**Q&A #2 to  
Request for Proposals (RFP)  
Statewide Public Safety Wireless Communications System  
RFP #060B9800036  
September 5, 2008**

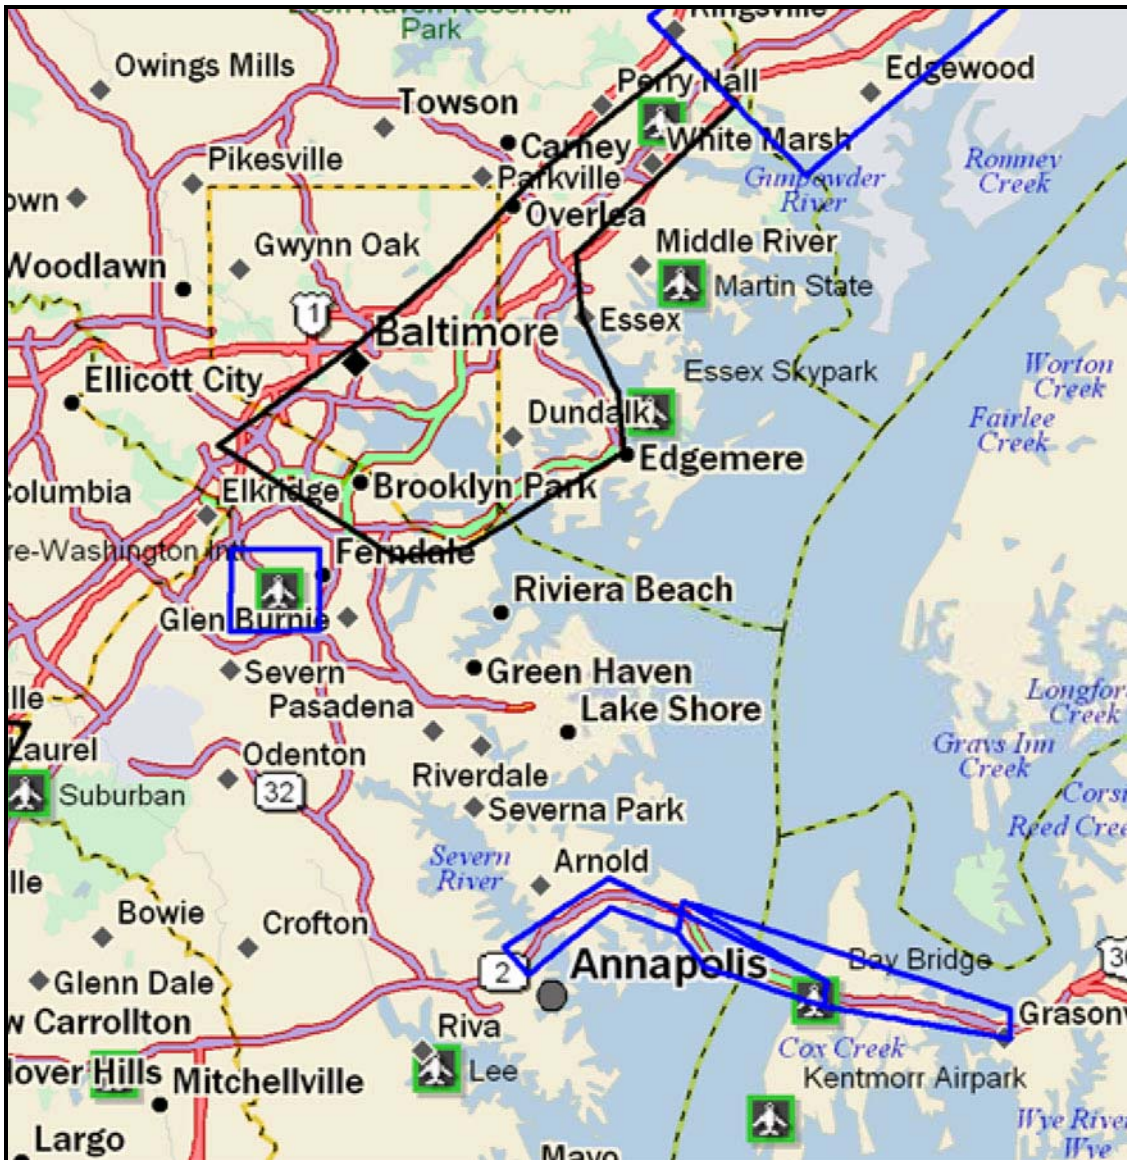
73. There appear to be typographical errors in the Bounded Area definitions for Region 1A and the W.P. Lane (Chesapeake Bay) Bridge areas. See the figure below. Can the MDIT check the coordinates and issue an Addendum?

**Answer: The State has revised Appendix #2 with Appendix #2 (Revision #1). See Addendum #5, Item #2.**
